RE: Site Plan Application
SPR2026-00035, Binns Road Data Centers

Review of the Site Plan (1st review), received in the Planning Office via digital submittal on 7/9/2026, has been completed by Planning. Attached or listed below you will find pertinent comments from the Planning Department. Other agency comments may be sent directly to you, included with this letter or accessible at the Hanover County Community Development Web Portal (<https://communitydevelopment.hanovercounty.gov/eTRAKiT/>).

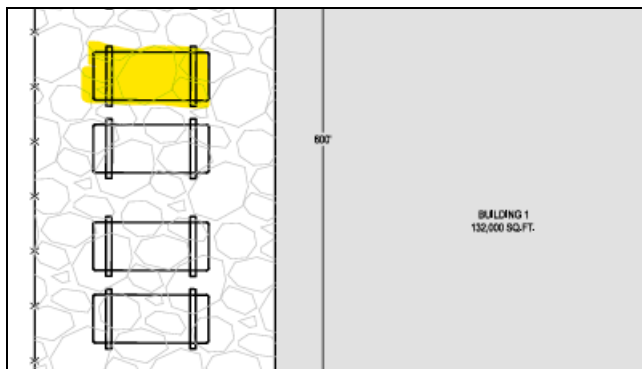
5. What is represented by the features highlighted in the screenshot below? Please label these on all Site Layout sheets.

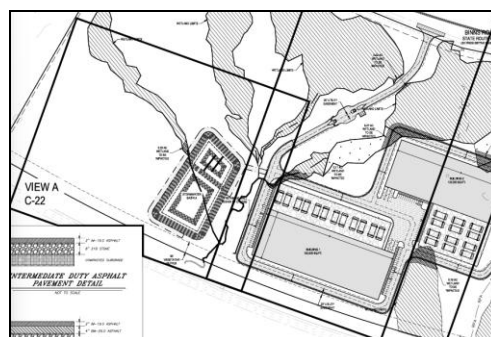
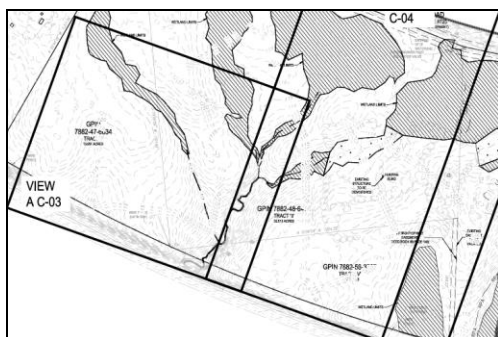
6. No portion of Stormwater Basin A (or any other improvement associated with the data center use) should be located on the A-1 parcel (GPIN 7882-47-6634). Stormwater Basin A is related to the data center use, which is not a permitted use in the A-1 zoning district (Screenshot on left shows the zoning district line, and the screenshot on right shows Stormwater Basin A for reference).

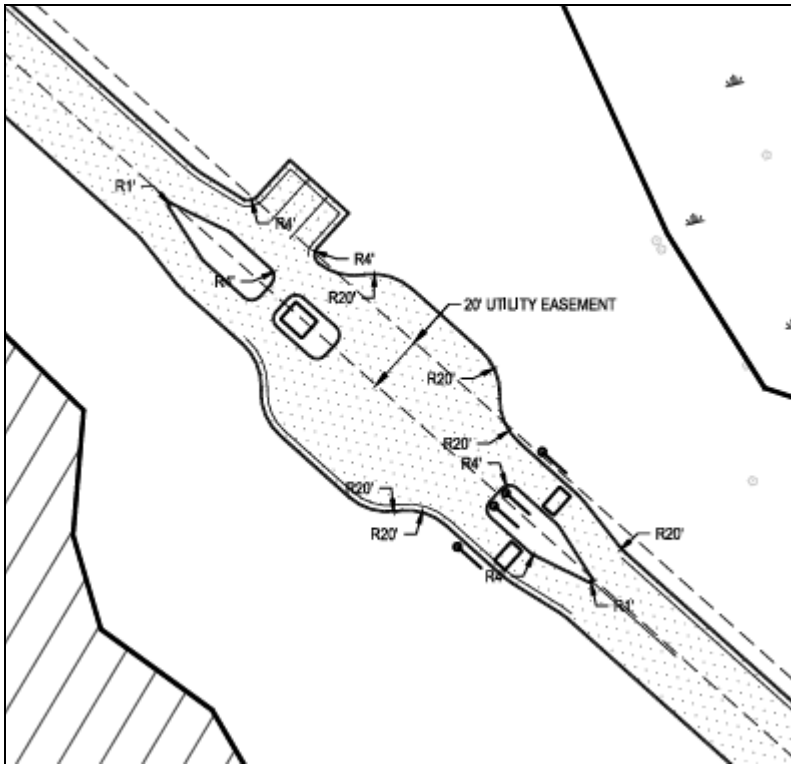
18. Please provide a detail for the proposed Security Fence(s) which encompass each building area, as well as add the proposed height and reference for the sheet that the detail is provided on in each of the labels/callouts for the security fence(s) (on all associated Site Layout sheets).

Please also note that any security fencing taller than 7 feet will require a Special Exception.

Additionally, are security gates proposed where the security fences cross the three (x3) unique interior access drives? If so, please label/callout these features (and note the proposed height) and provide a relevant detail while also referencing the sheet the detail is located on in the labels/callouts (on all associated Site Layout sheets).

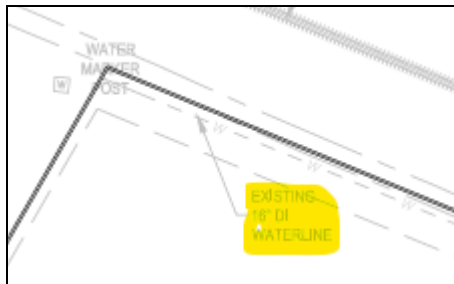
19. On all associated Site Layout sheets, please label/add callouts/provide more information regarding the features/improvements shown in the screenshot below, which are located in three (x3) unique areas along the proposed interior access drives:
